OFFSHORE OPERATORS COMMITTEE

March 5, 2002

Re: Notice of Proposed Rulemaking
Procedures for Dealing with Sustained Casing Pressure

Figure 5: Wellhead Housing Side Outlets

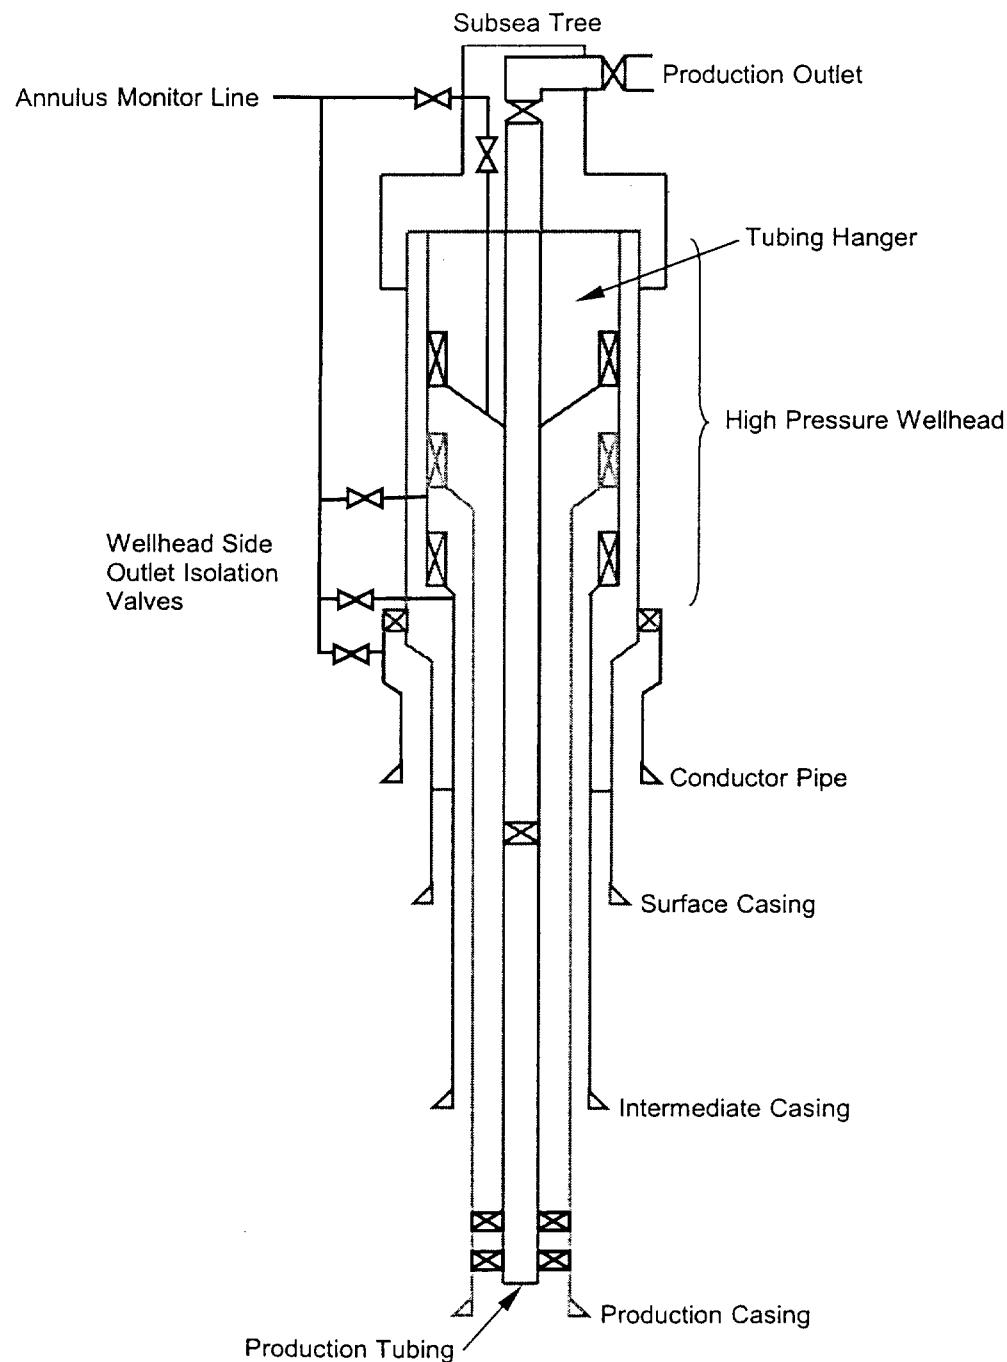
Note: This concept is in direct violation of API Spec 17D Paragraph 1001.5b(1)(c) which states that “body penetrations within the [high pressure wellhead] housing are not permitted”. Penetrations through the non-retrievable, primary pressure and structural member of the subsea well foundation have not been considered an acceptable practice from a safety perspective.
